Contract Number 9419	Contract Title Lacamas Creek Bridge Replacement	Federal Aid Number #STBG-0506(004)
Change Order Number 001	Change Description Differing Site Conditions	Date Jul 8, 2020
Region Southwest Region	Project Engineer Colin Newell	Phone Number 360-740-8600
Prime Contractor / Design-Builder Farline Bridge, Incorporated

CONTRACT NO: 009419 FEDERAL AID NO: STBG-0506(004)
CONTRACT TITLE: SR 506, LACAMAS CREEK BRIDGE REPLACEMENT
CHANGE ORDER NO: 1 DIFFERING SITE CONDITIONS

SR 506
LACAMAS CREEK BRIDGE REPLACEMENT
LACAMAS CREEK BRIDGE NO. 506/106
SHAFT
DETAILS 1 OF 2

SHEET NO. BR5

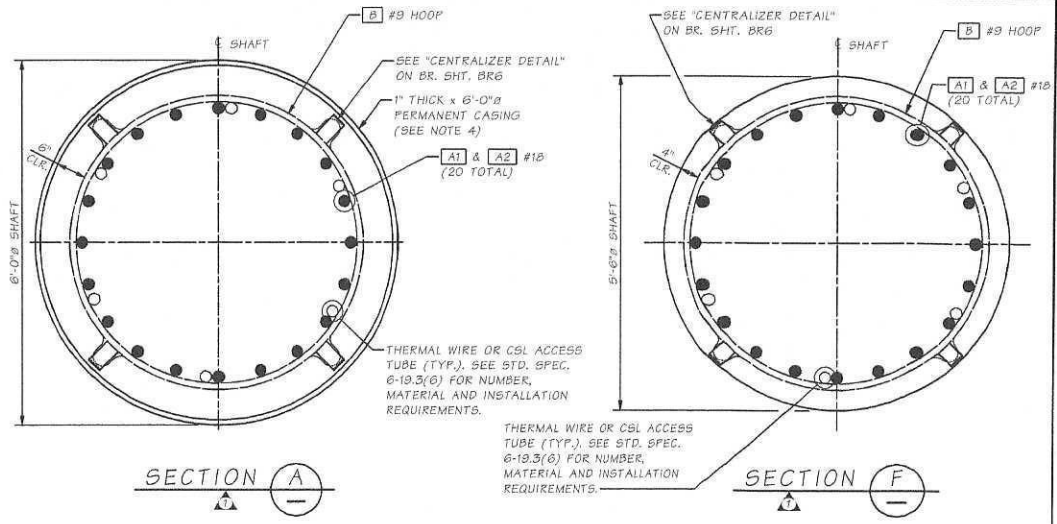
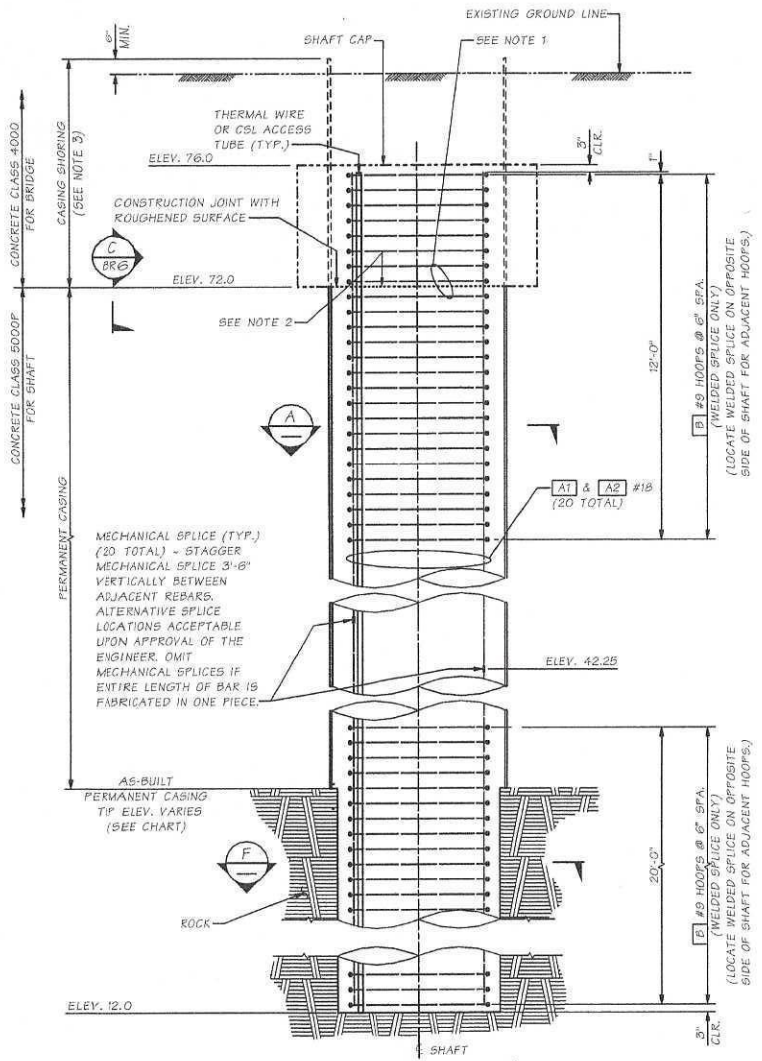
This change order revises Plan Sheets BR5, BR6, and BR35 as shown on sheets 4, 5 and 6 of this change order and compensates the Contractor for the Differing Site Condition (Changed Conditions) encountered during construction of the 6 foot diameter shafts at piers 1 and 2 of Bridge NO. 506/106.

Construction requirements for the item "Cost via Differing Site Conditions" pertaining to constructing 5.5 ft. diam. shaft shall conform to the requirements of revised plans shown on sheets BR5, BR6 and BR35 of this change order, pertaining to force account for differing site condition additional cost shall be in accordance with Section 1-09.6, salvaged steel shall be as follows: Unused reinforcing bars and casing from Bid Item No. 20, "Constructing 6 Ft. Diam. Shaft", shall be salvaged.

AS-BUILT PERMANENT CASING TIP ELEVATION

SHAFT	TIP ELEV.
1A	27.61
1B	29.30
1C	26.70
2A	23.05
2B	24.44
2C	25.03
